Proposal for 06 series of amendments to UN Regulation No. 95 (Lateral impact)

Submitted by the Working Party on Passive Safety *

The text reproduced below was adopted by the Working Party on Passive Safety (GRSP) at its seventy-third session (ECE/TRANS/WP.29/GRSP/73 para. 25). It is based on ECE/TRANS/WP.29/GRSP/2023/18 as amended by annex VI to the report. It is submitted to the World Forum for Harmonization of Vehicle Regulations (WP.29) and to the Administrative Committee (AC.1) for consideration at their November 2023 sessions

Figure 2a
Blocks 1 and 3

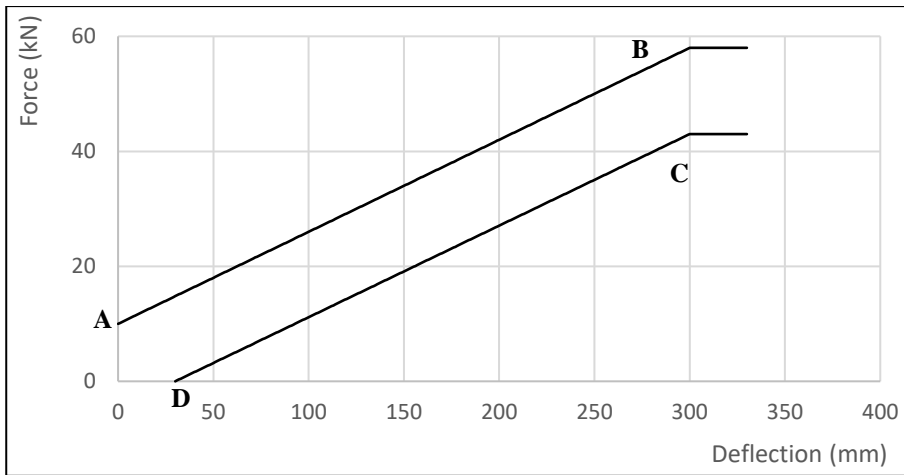
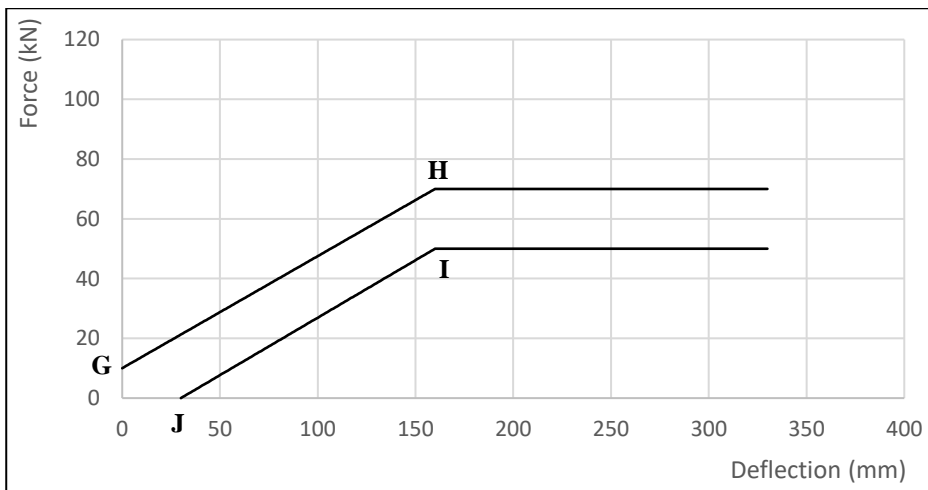
Annex 5 – Appendix 2, amend to read:

Deflection	Force
A	0 mm	10 kN
B	300 mm	58 kN
C	300 mm	43 kN
D	30 mm	0 kN

Figure 2b
Block 2

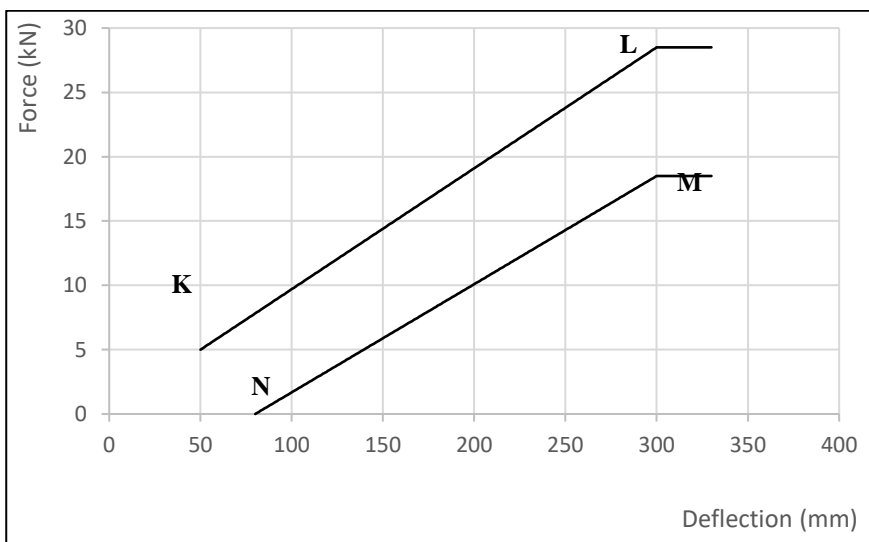
Deflection	Force
G	0 mm	10 kN
H	160 mm	70 kN
I	160 mm	50 kN
J	30 mm	0 kN

Figure 2c
Block 4

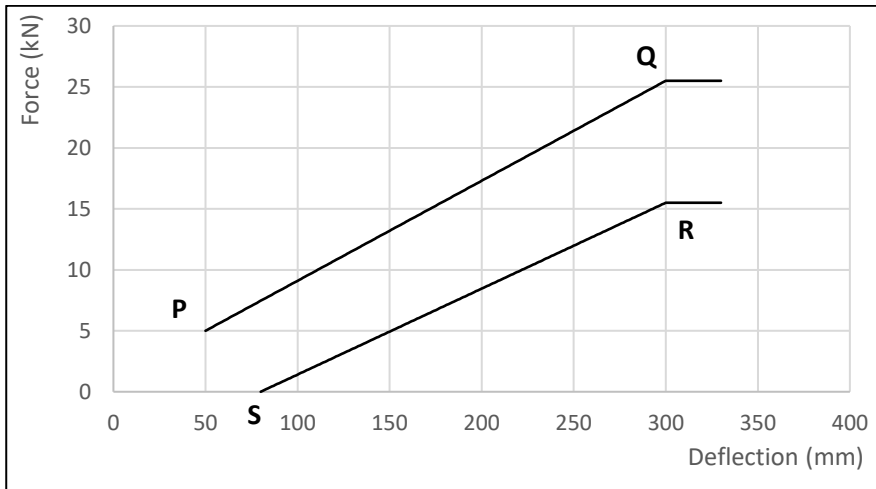
Deflection	Force
K	50 mm	5,0 kN
L	300 mm	28,5 kN
M	300 mm	18,5 kN
N	80 mm	0 kN

Figure 2d
Blocks 5 and 6

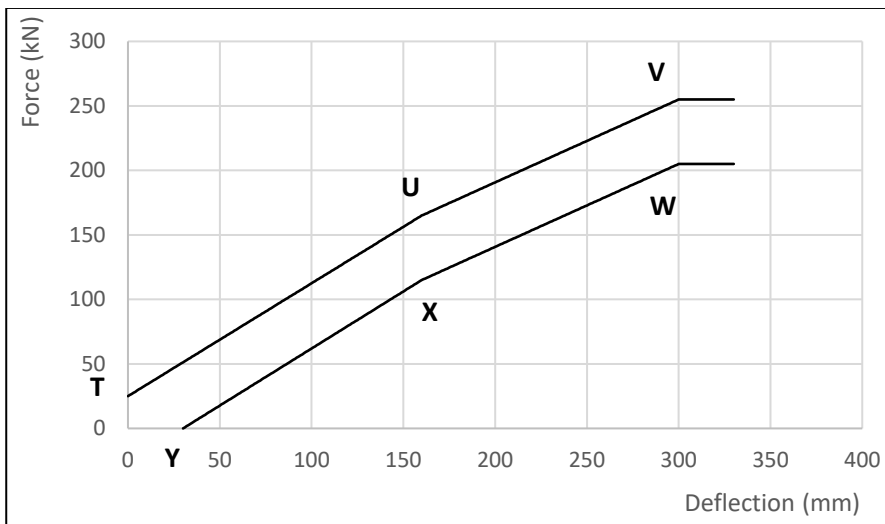
Deflection	Force
P	50 mm	5,0 kN
Q	300 mm	25,5 kN
R	300 mm	15,5 kN
S	80 mm	0 kN
